RS-02-205

U. S. Nuclear Regulatory Commission
ATTN: Document Control Desk
Washington, DC 20555-0001Braidwood Station, Units 1 and 2
Facility Operating License Nos. NPF-72 and NPF-77
NRC Docket Nos. STN 50-456 and STN 50-457Byron Station, Units 1 and 2
Facility Operating License Nos. NPF-37 and NPF-66
NRC Docket Nos. STN 50-454 and STN 50-455

Subject: Response to Request for Additional Information Supporting a License Amendment Request Revising the Technical Specifications Surveillance Requirements for Containment Spray Nozzles

Loss of Foreign Material Integrity Events

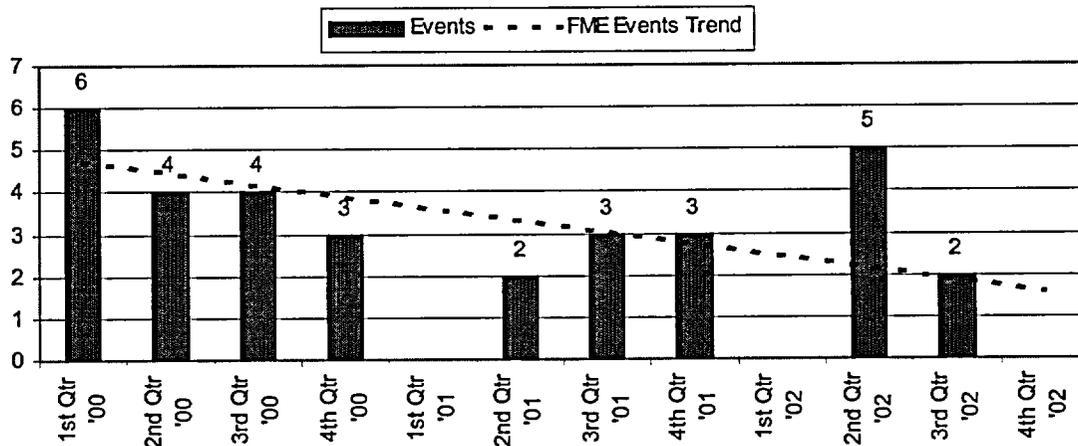
Question 2

Please explain the steps you will take to ensure that, after revising TS SR 3.6.6.8 as proposed, the FME program at each site will be maintained at the level necessary to provide assurance that the containment spray nozzles will remain free from blockage during future maintenance activities or testing. In your explanation, please discuss your evaluation of the current program as implemented, including any actions you plan to take to enhance or strengthen the program.

As depicted on the below graph, the overall FME event trend has been on an improving trend from 2000 through present.

The above information clearly shows that there have been FME issues at Braidwood Station in the past; however, none of the FME events involved the CS system. The FME issues/problems have been well documented and entered into the station's corrective action program. Based on the above discussion, there remains high confidence that the CS System is free of foreign material.

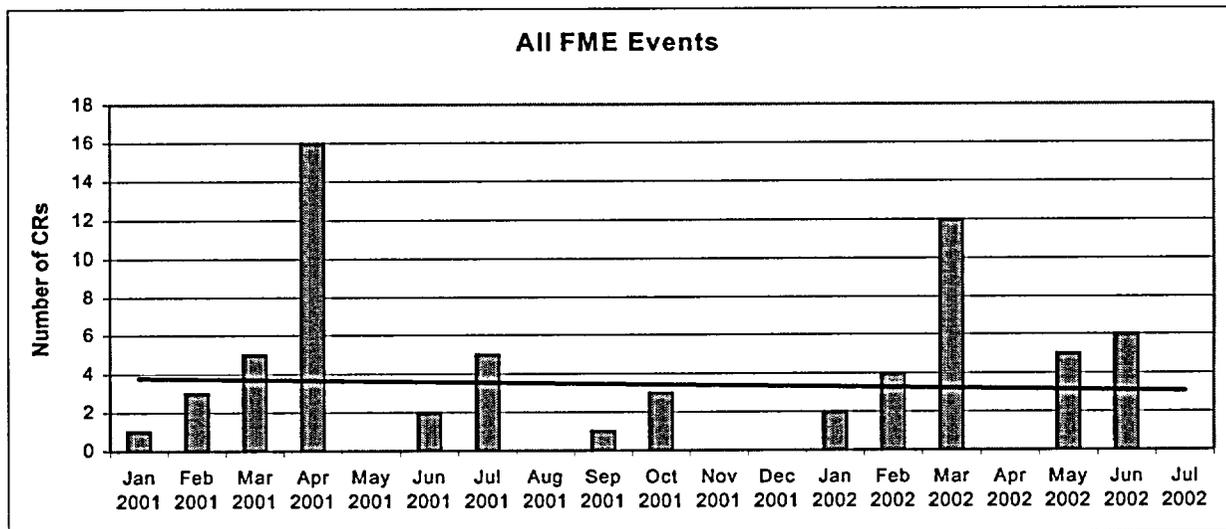
1. *Describe what assurance you have that no foreign material could have entered each plant/unit's containment spray system during each of the occasions.*
2. *In particular, please explain why any plant-wide concerns with the implementation of the FME program would not have affected the confidence that the containment spray system is free from debris.*

A Common Cause Analysis (CCA) was performed at Byron Station in August 2002 to evaluate FME issues and concerns. This analysis identified 65 Condition Reports (CRs) that were written addressing FME events between January 2001 and July 2002. In summary, the CCA identified that a potential common cause of the FME issues was due to ineffective management/supervisory oversight/ownership of the FME program.

As depicted on the below graph, the overall FME event trend has been on a slightly improving trend over the duration of the analysis (i.e., January 2001 through July 2002).
